STATE OF CONNECTICUT
DEPARTMENT OF ENVIRONMENTAL PROTECTION

HEARING REPORT

Regarding Regulations for the Abatement of Air Pollution:
Proposed Amendment of Section 22a-174-36b of the
Regulations of Connecticut State Agencies

Date of Hearing: August 25, 2005

Figure 2: AVL simulated acceleration results for minivan vehicle segment, showing baseline and case 4 (the downsized turbocharged case)

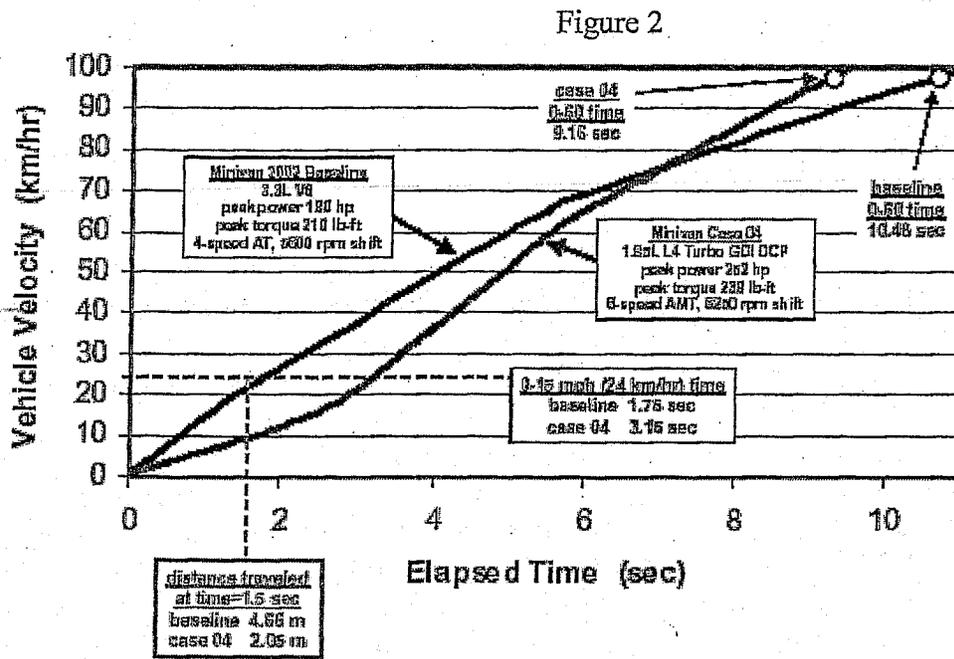
The plot in Figure 2 shows the simulated acceleration response of the 2002 baseline minivan configuration compared with the simulated response of minivan case 4 (the downsized turbocharged case, which was one of the configurations used to set the California near-term standard). The simulation analysis was performed using AVL CRUISE, and it exactly matches the analysis done for CARB.

GM comments that Figure 2 demonstrates the launch and early acceleration response of the downsized turbocharged powertrain for minivan case 4 is much worse than the baseline powertrain in terms of capability. Even though the 0-60 acceleration of case 4 is faster than that of the baseline, the performance lags when the vehicle is below 47 mph (75 km/hr). In case 4 it takes an engine with 252 horsepower to match the 0-60 time of the baseline 180 horsepower minivan engine. The unrealistically high horsepower value required for a baseline minivan

GM comments that Figure 2 also highlights some typical metrics regarding launch performance: 0-15 mph time and distance traveled at 1.5 seconds. Various manufacturers and powertrain developers use their own metrics, which may be slightly different, but those shown in Figure 2 are representative of launch. Clearly, minivan case 4 suffers from poor launch.
